Service Bulletin

S.B. No: 191

Title: INSPECTION OF INTEGRITY OF FRAME 6 AND 7 JOINT BONDING

Applicability: T67B, T67C Series, T67M, T67M-MkII, T67M200 and T67M260.

FIGURE 1
INDICATING POINTS OF INSPECTION OF BUFFER & FRAMES

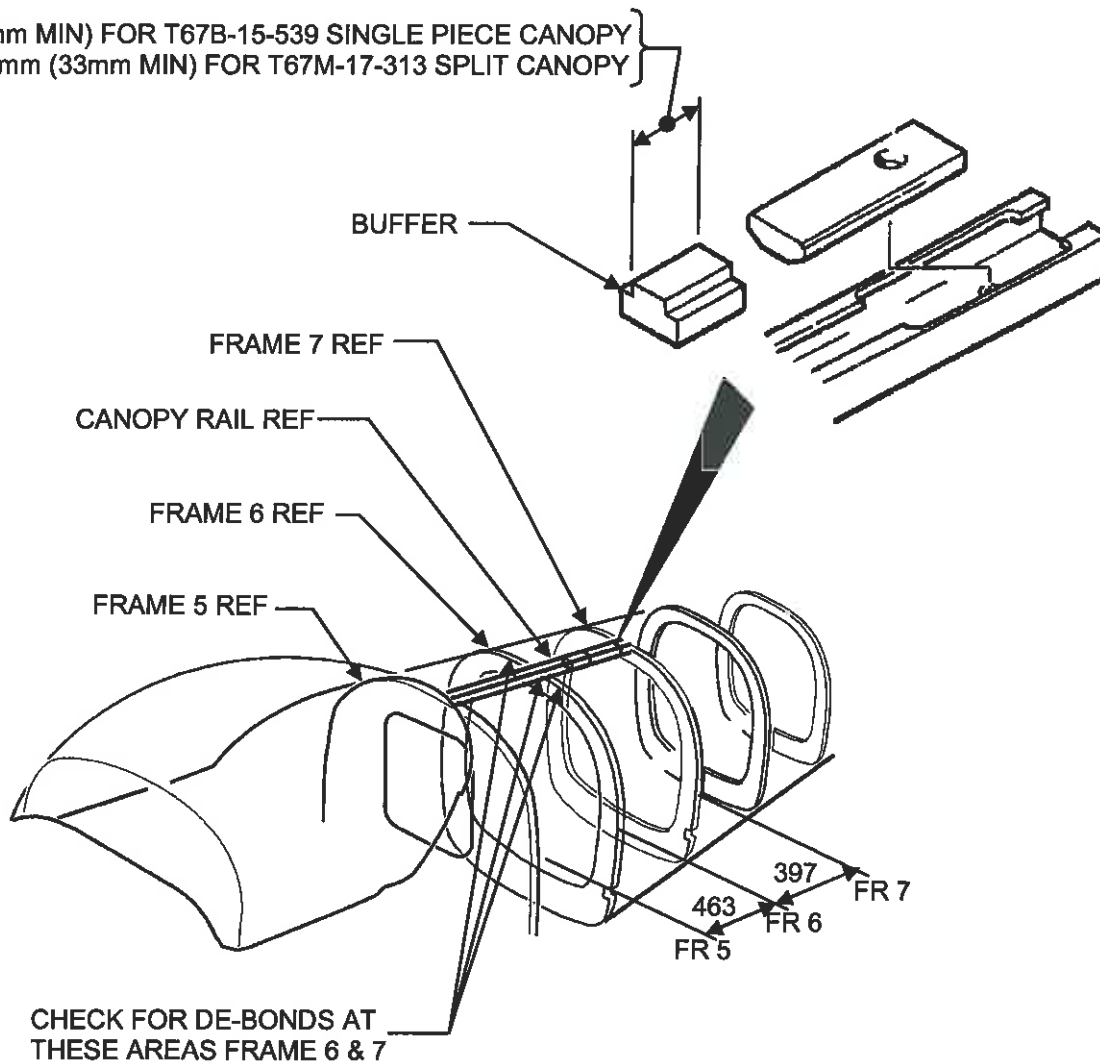
- 1 Check canopy slide rail for canopy buffer, reference Figure 1. Check length of buffer, for single piece canopies length should be 50mm and for split canopy length should be 35mm +1/-0mm. If buffer is missing or lengths measure less than 2mm than stated at Figure 1, then replace with T67B-15-539 for single piece canopy; or T67M-17-313 (issue 3 & subs.) for split canopy.
- 2 Place trestle under bump stop of aircraft.
- 3 Gain access to aft fuselage via Frame 5 access panel and position crawl boards into aft fuselage. These are available from MSAC (Marshall Slingsby); order part numbers T67G-88-025 port and T67G-88-026 stbd. Ensure no damage to controls, structure, cable, etc. whilst positioning boards and during course of any work there in.
- 4 Inspect bond of Frames 6 and 7 to top skin either side of canopy rail GRP preform and to the preform.

50mm (48mm MIN) FOR T67B-15-539 SINGLE PIECE CANOPY
35mm +1/0mm (33mm MIN) FOR T67M-17-313 SPLIT CANOPY
